Amdt. Dated: February 28, 2005

Reply to Office Action of: November 30, 2004

**REMARKS/ARGUEMENTS**

Fig. 8

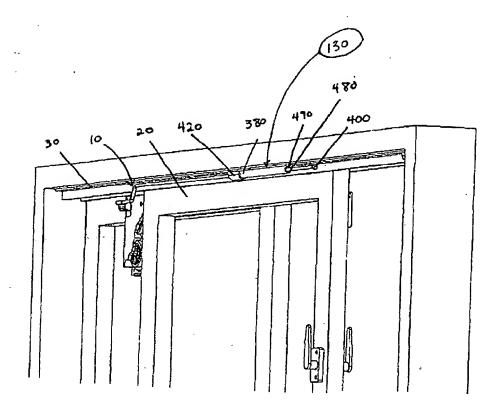
The Examiner objected to the drawings because they did not include reference numeral

The attached sheet of drawings includes changes to Fig. 8. This sheet replaces the original sheet including Fig. 8. Previously omitted element 130 has been added.

130 mentioned in the description. Applicant has attached a replacement sheet to this amendment

that includes reference numeral 130. Accordingly, applicant respectfully requests withdrawal of
